**FOURTH AMENDMENT CONTRACT NO. 2022-26 WATER PIPELINE BRIDGE REPLACEMENTS –
HABERLAND/WOODHAVEN/N. TOLEDO BLADE FOR CHANGE IN SCOPE AND TIME EXTENSION**

Attachment No. 1 to Fourth Amendment to Contract No. 2022-26

W. PRICE BOULEVARD
 PROPOSED UTILITIES WITH NEW ROAD
 STA. 102+80 TO STA. 107+00

SHEET NO. PP-13

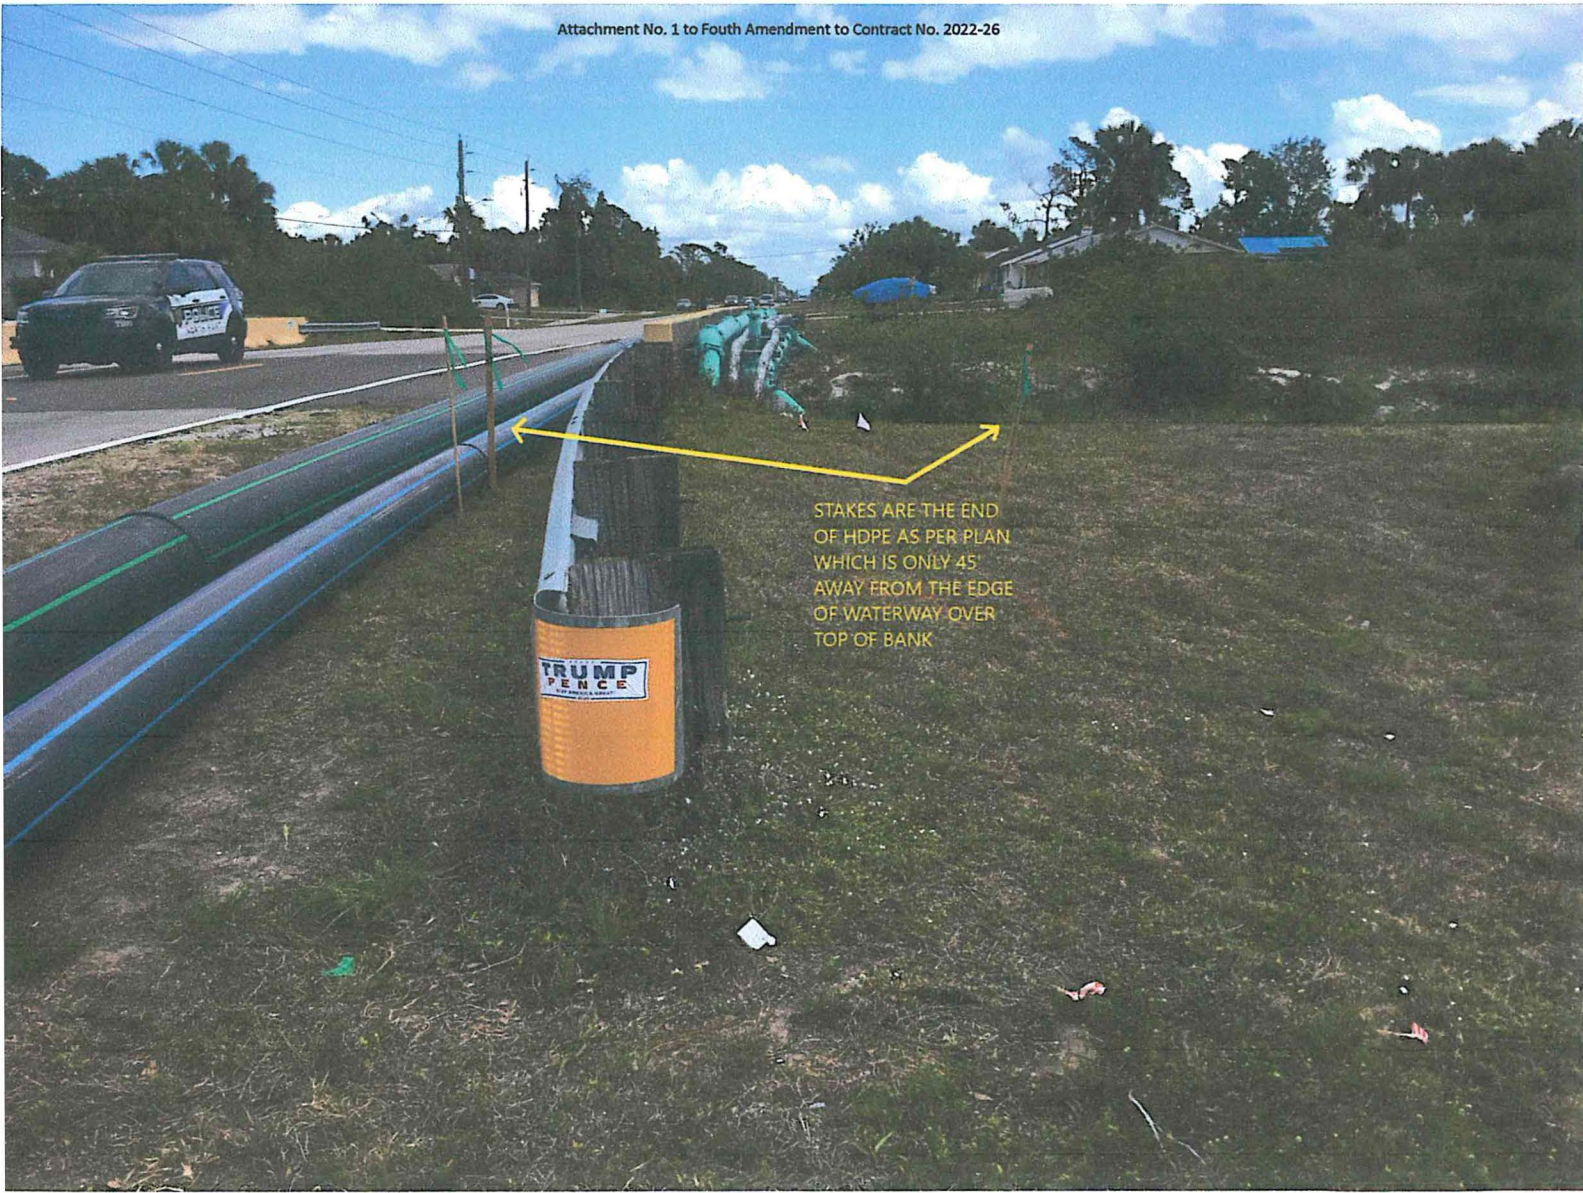
THE HDPE WILL HAVE TO BE EXTENDED 100' TO THE WEST, FROM STA 105+50 TO STA 104+50, AS PER PLAN THE HDPE IS SUPPOSED TO STOP AT STA 105+50 BUT THAT IS ONLY 45' AWAY FROM THE EDGE OF THE WATERWAY IN ORDER TO DEFLECT THE HDPE BACK UP AFTER GOING UNDER THE WATERWAY, THE EXISTING ASPHALT GRADE ON THE BRIDGE IS AT AN ELEVATION 10.50 + OR - AND THE TOP OF WATER IS AT A ELEVATION 0.00 THE TOP OF THE HDPE HAS TO BE AT A MINIMUM OF 10' BELOW THE BOTTOM OF THE WATERWAY WHICH HAS THE HDPE AT A DEPTH OF OVER 35' GOING UNDER THE WATERWAY, ACCORDING TO THE DRILL CONTRACTOR THE HDPE CAN NOT BE DEFLECTED BACK UP IN THAT SHORT DISTANCE TO STOP THE HDPE AT STA 105+50 AS PER SPECIFICATIONS SO IT HAS TO BE EXTENDED 100' TO THE WEST WHICH HAS IT STOPPING AT STA 104+50.

STAKES ARE THE END OF HDPE AS PER PLAN WHICH IS ONLY 45' AWAY FROM THE EDGE OF WATERWAY OVER TOP OF BANK
